Proposed Turkey Point Units 6 and 7
Docket Nos. 52-040 and 52-041
FPL Revised Response to NRC RAI No. 02.05.04-18 (eRAI 6006)
L-2014-111 Attachment 17 Page 26 of 26

QUESTIONS from Geosciences and Geotechnical Engineering Branch 1 (RGS1)

Figure 7 Simulated Discontinuities, 1x Required Bearing Demand

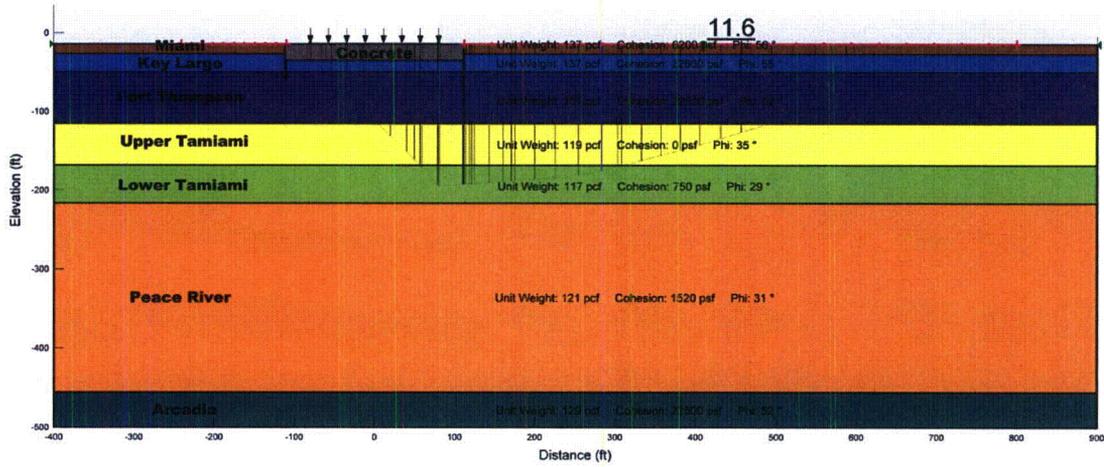
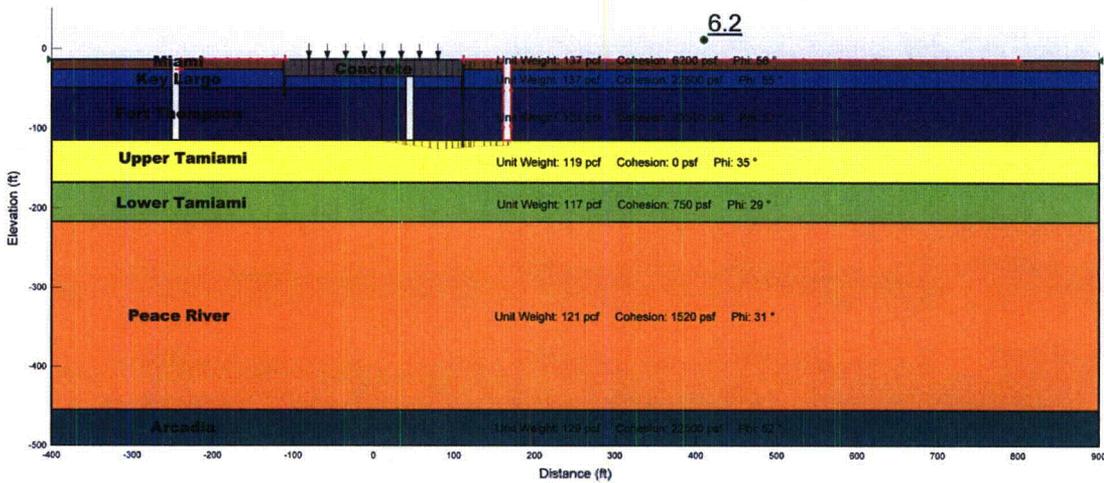
In SLOPE/W, the extreme case of simulated FD4 zones is evaluated differently than the other SLOPE/W cases, by finding the factor of safety when the bearing demand pressure of 8.9 ksf is applied instead of finding the allowable bearing capacity for a prescribed factor of safety. The following failures are found for configurations with and without simulated FD4 zones (Figures 6 and 7).

The factor of safety with simulated FD4 zones (FS = 6.2) is almost half of the factor of safety with no FD4 zones (FS = 11.6). This low factor of safety is still more than double the required FS=3.0

Figure 8 Plastic Deformation from PLAXIS 2D Analysis, 1x Required Bearing Demand

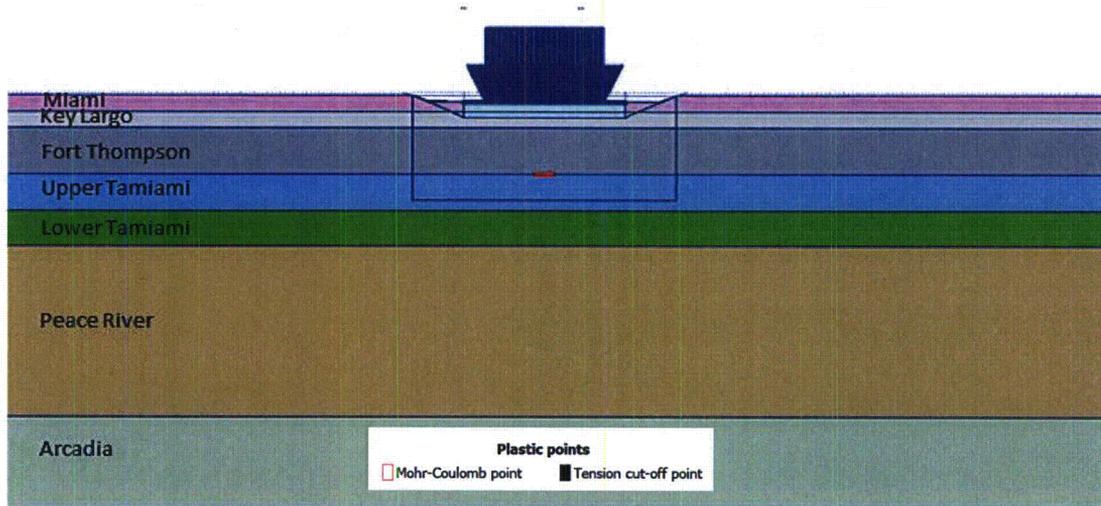
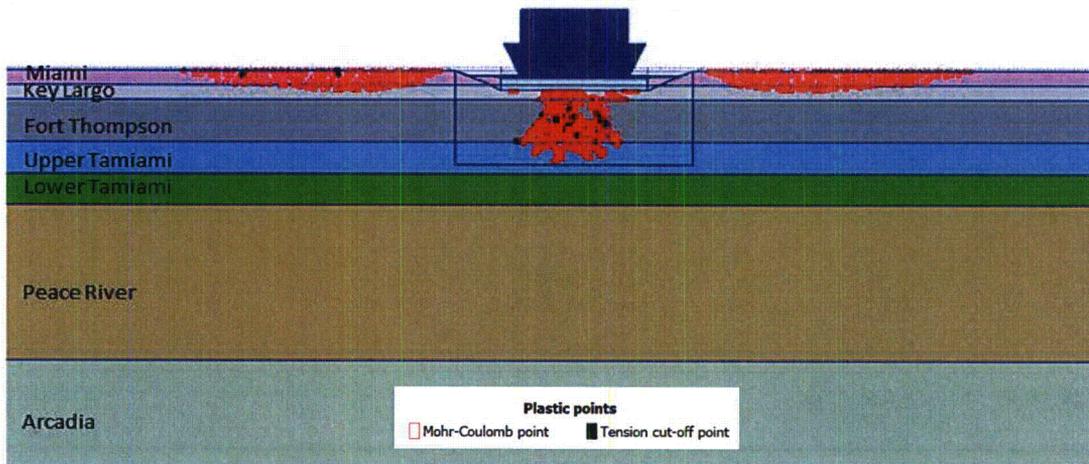
In PLAXIS 2D, the beam tension failure is checked for the required bearing demand (8.9 ksf) as well as three times the required bearing demand (26.7 ksf). In Figures 8 and 9, points in tension are shown with black circles. As evident in both cases, there are minimal black circles, i.e., no tensile failure is observed.

Figure 2.5.4-259
SLOPEW Analysis with Simulated FD4 Zones, 1x Required Bearing Demand

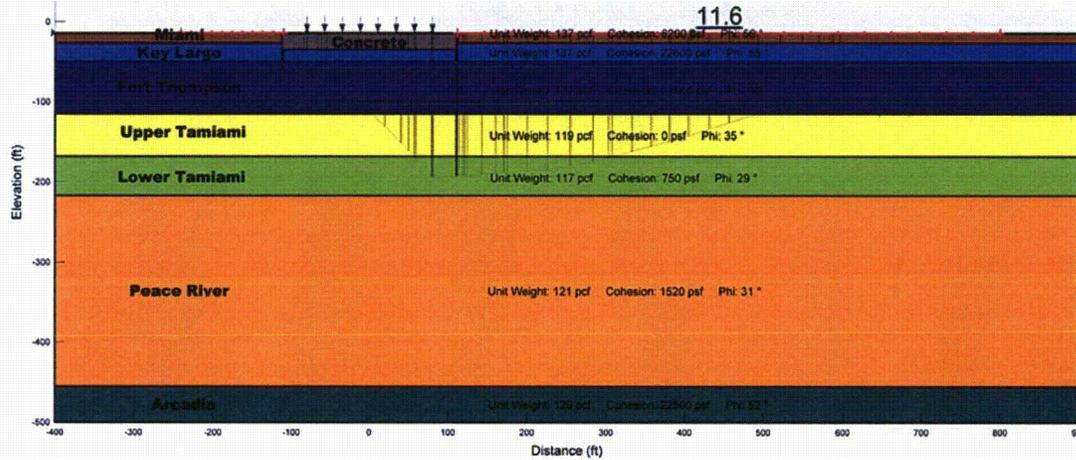
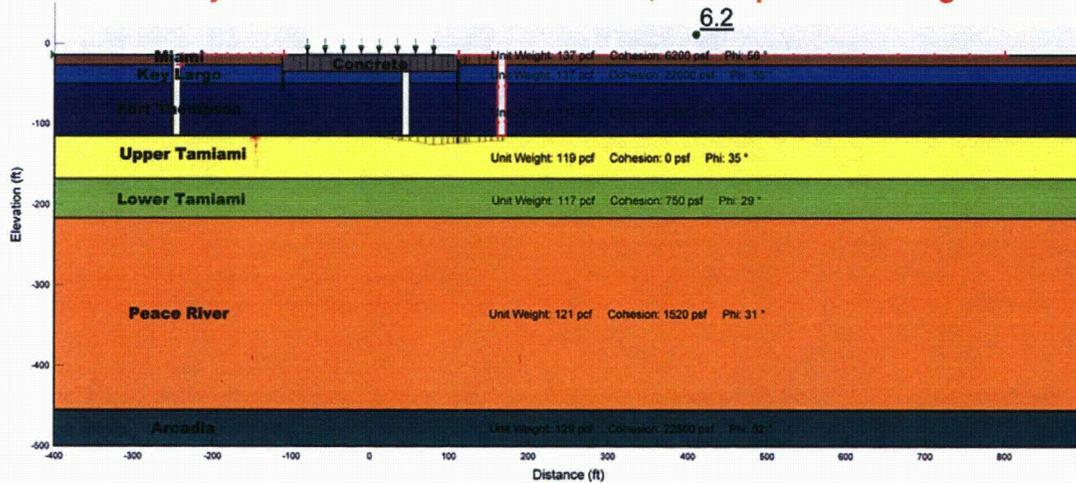
In SLOPE/W, a case is considered where zones representing open discontinuities are placed beneath and to the side of the NI to represent zones of FD4 material as shown in Figure 2.5.4-254. This case is unrealistic because joints in FD4 rock are only moderately open, but the comparison to no simulated joints is presented in Figures 2.5.4-258 and 2.5.4-259.

Figure 3 Comparison of Stress Distributions

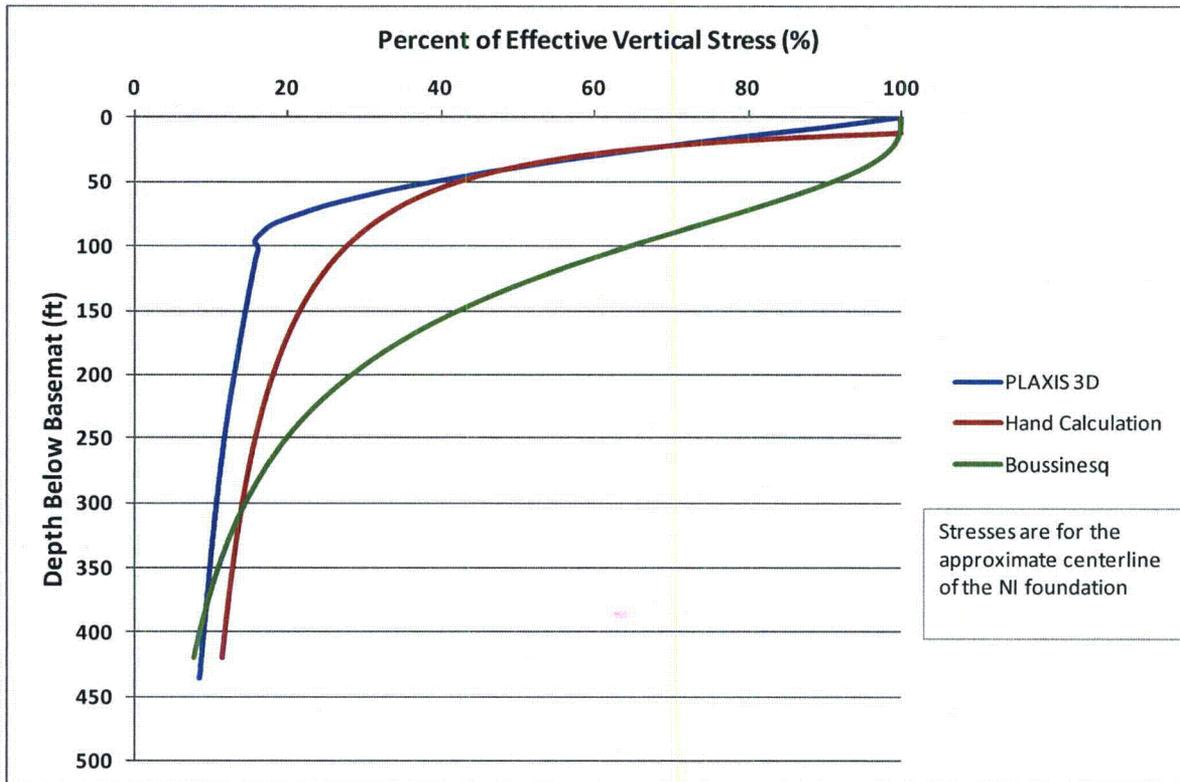
FSAR Subsection 2.5.4.10.3 indicates that the stress distribution used for the settlement calculation was based on Boussinesq distribution. The Boussinesq distribution is based on the assumption that the soil is a homogeneous, linear elastic, isotropic half-space media. In accordance with NUREG-0800, Standard Review Plan, Chapter 2.5.4, "Stability of Subsurface Materials and Foundations," please justify how this method is applicable for the site since a considerable variation in Elastic modulus was reported in the FSAR.

As shown in Figure 3, Boussinesq is highly conservative as it estimates higher stresses in both the rock and soil layers. The stress distribution found by using Reference 1 is similar to but more conservative than the PLAXIS 3D stress distribution. The difference between the PLAXIS 3D and the Milovic stress distributions can be attributed to the fact that PLAXIS 3D estimates the stresses based on all of the soil and rock strata, while the Milovic stress distribution approximates the system as two layers.

Figure 1 5% Damping ARS at Ground Surface – Near NI, Envelope of LF and HF

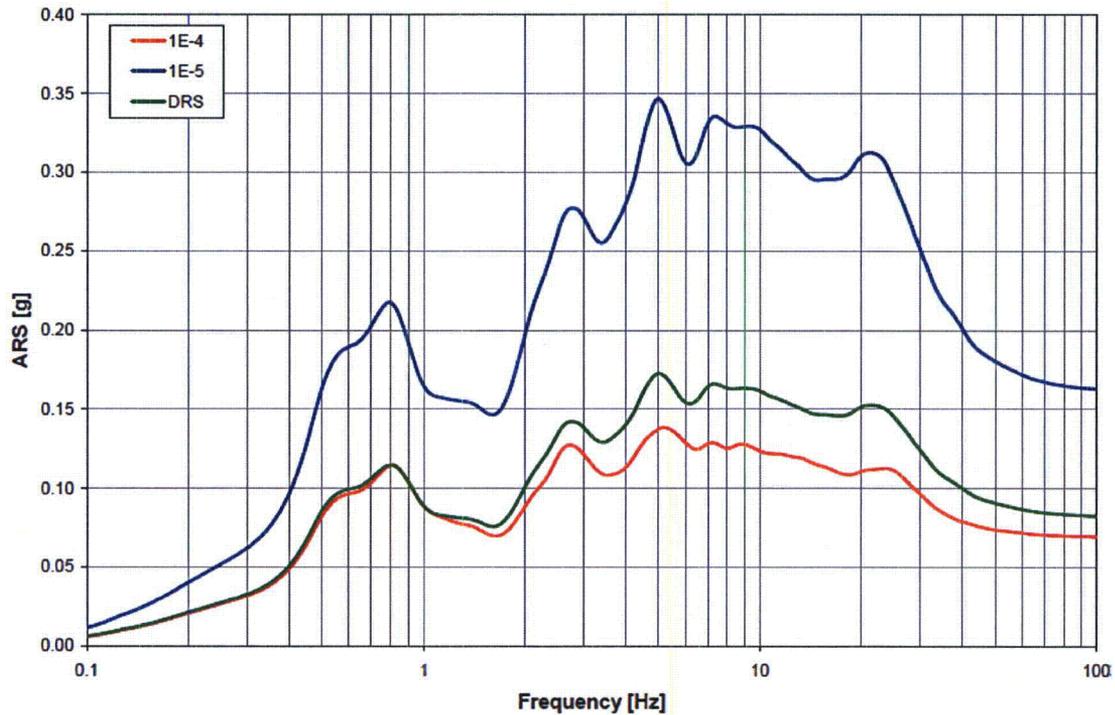
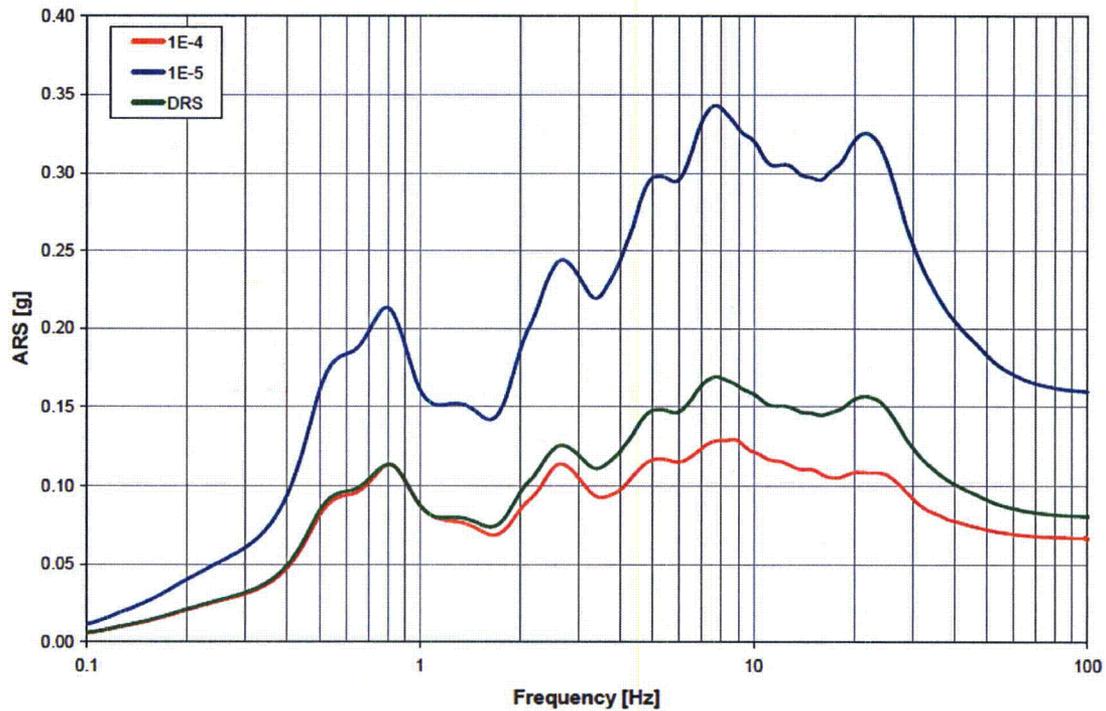
Figure 2.5.2-252 shows the input motion (GMRS) developed for the site, the GMRS is located at Elevation 35. In this Figure the z_{pa} is approximately 0.058g. However, the elevation of the GMRS is considerably lower than the surface of the soils adjacent to the basement walls that are to be evaluated for seismic lateral earth pressure. In accordance with NUREG-0800, Standard Review Plan, Chapter 2.5.4, "Stability of Subsurface Materials and Foundations," please clarify on the definition of the design ground motion, and how that motion is consistent with Appendix S to 10CFR50.

FSAR Figure 2.5.2-253 and FSAR Table 2.5.2-228 show the zero period acceleration (z_{pa}) for the GMRS as about 0.058g. This z_{pa} value was not considered appropriate when computing lateral earth pressure because it was developed for El. -35 feet. The design response spectra (DRS) at 5% damping, calculated at the ground surface for the near nuclear island (NI) and far from NI soil sites, were considered appropriate for computing lateral earth pressure, using the envelope of low frequency (LF) and high frequency (HF) acceleration response spectra (ARS) at 10⁻⁴ and 10⁻⁵ annual probability of exceedance. These ARS envelopes and the DRS are plotted in Figures 1 and 2 for the near NI and far from NI soil sites, respectively. From Figures 1 and 2, the peak ground acceleration at the ground surface is equal to approximately 0.0824g and 0.0806g (DRS at 100 Hertz [Hz]) for the near NI and far from NI soil sites, respectively.

Similarly, for the computation of at-rest seismic pressure using ASCE 4-98 (FSAR Section 2.5.4 Reference 277), an acceleration of 0.1g, rather than the peak ground acceleration of 0.0824g (near NI) or 0.0806g (far from NI), is conservatively used.

Figure 1 Active Earth Pressure Considering a 500 psf Surcharge on Fill

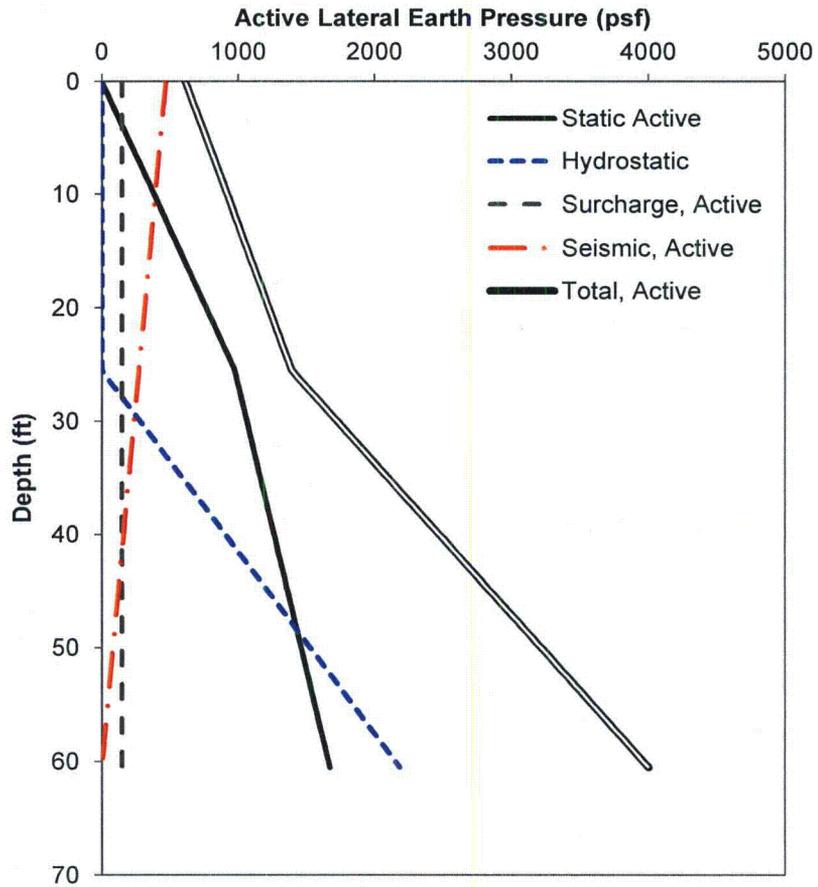
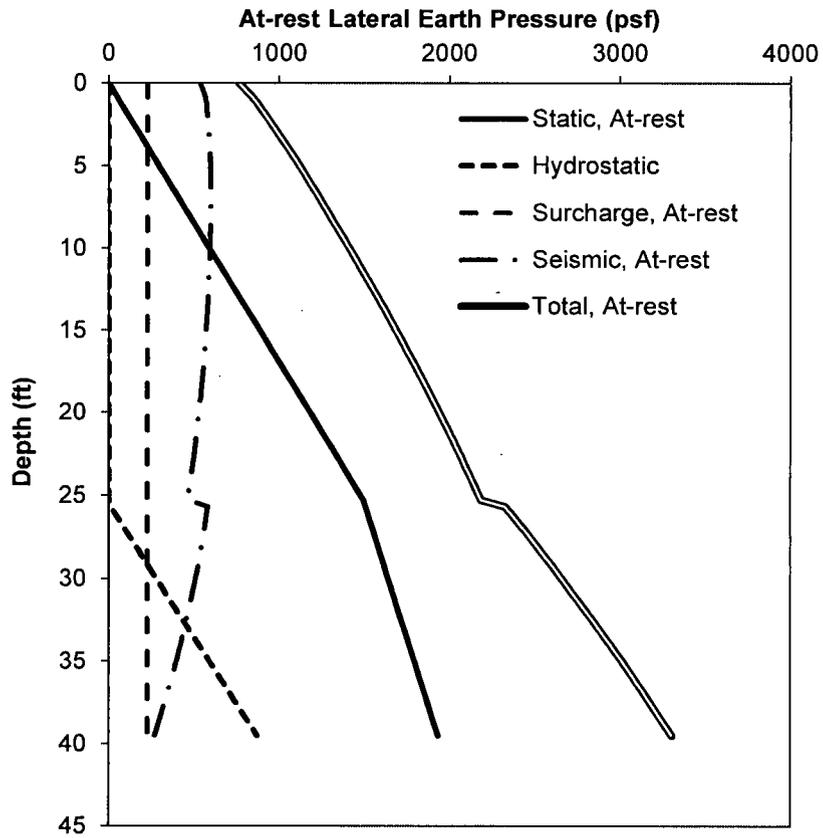
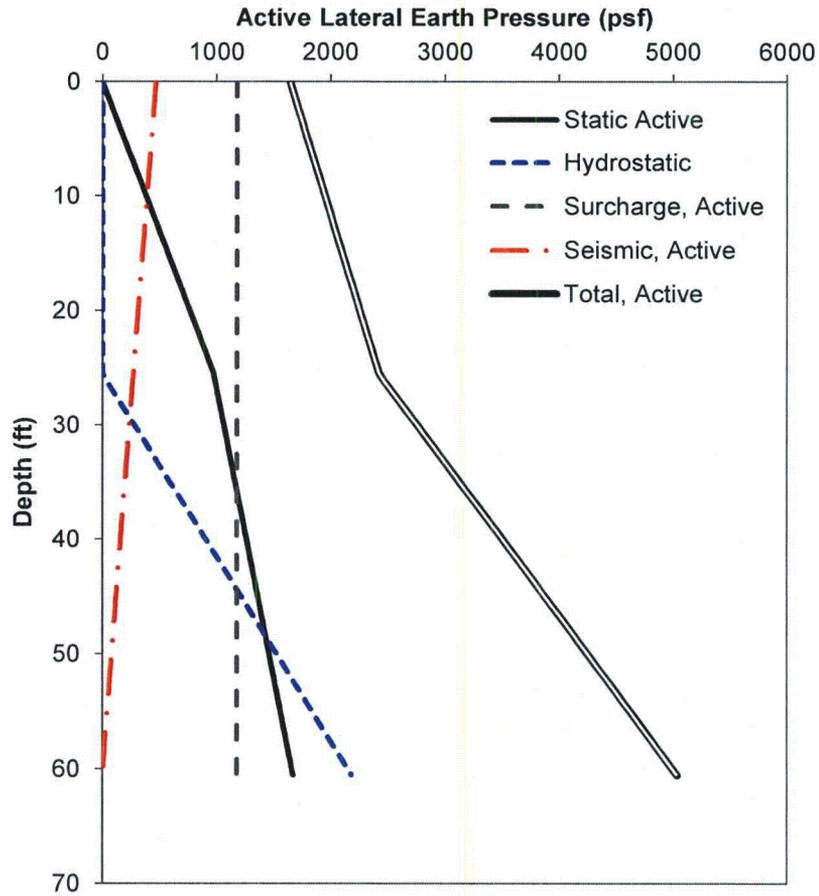
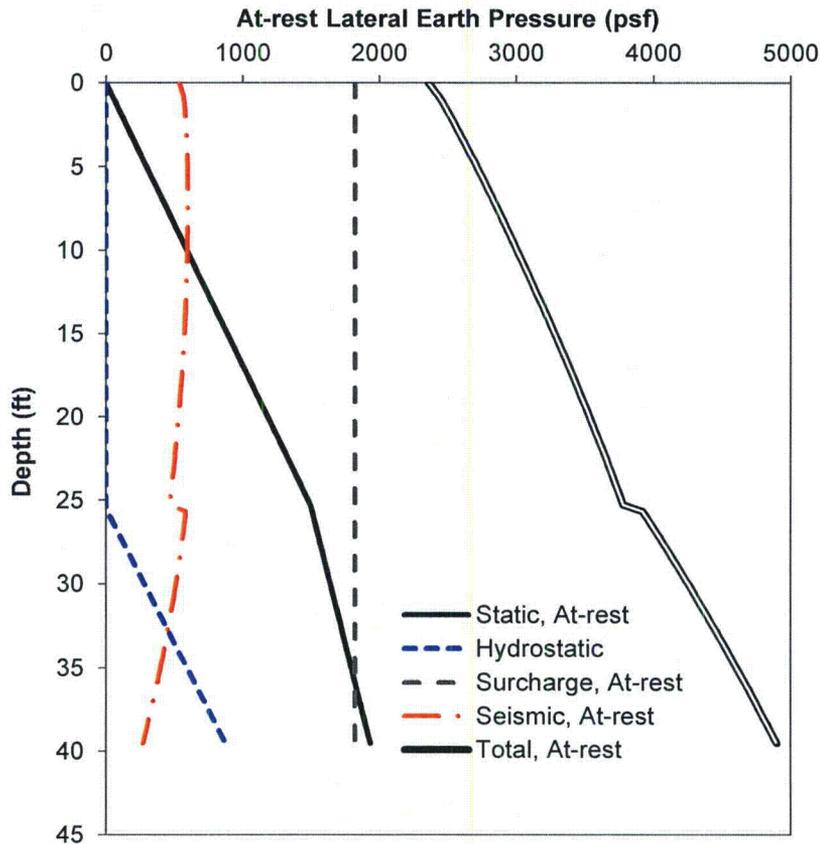
FSAR Section 2.5.4.10.4.3 states that a surcharge pressure of 500 psf was included when calculating the lateral earth pressures, however the calculation for COL static and seismic lateral earth pressures states that the adjacent building loads and the equipment loads were not considered. In accordance with NUREG-0800, Standard Review Plan, Chapter 2.5.4, "Stability of Subsurface Materials and Foundations," please describe the selection of 500 psf.

As indicated in FSAR Subsection 2.5.4.10.4.3, an area-wide surcharge pressure of 500 pounds per square foot (psf) is included in the earth pressure calculations. For the active condition presented in Figure 1 and for the at-rest condition presented in Figure 2, this loading represents the temporary construction loading, and does not include the permanent adjacent building loads. As indicated in FSAR Subsection 2.5.4.10.4.3, the validity of this pressure will be reviewed during the detailed design phase. This temporary loading is conservatively twice the typical design pressure for heavy truck loading (Reference 1).

To address adjacent building loads, an additional case considering a surcharge pressure of 4000 psf is presented in Figures 3 and 4. This surcharge is adopted because it is the highest expected building bearing pressure for the buildings founded on fill around the nuclear island. This pressure will also be reviewed during the detailed design phase.

FSAR Figure 2.5.4-239 ~~Lateral Earth Pressure Diagram: Active Case~~ Active Earth Pressure Considering a 500 psf Surcharge on Fill

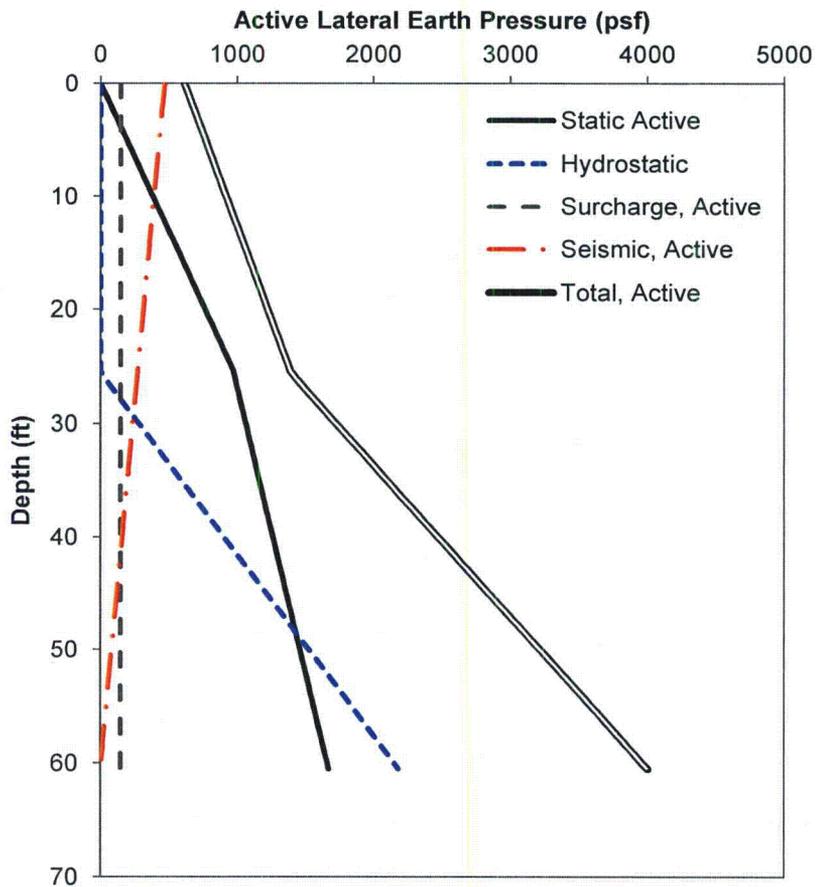
FSAR Figure 2.5.4-239 will be replaced with the following figure in a future revision:
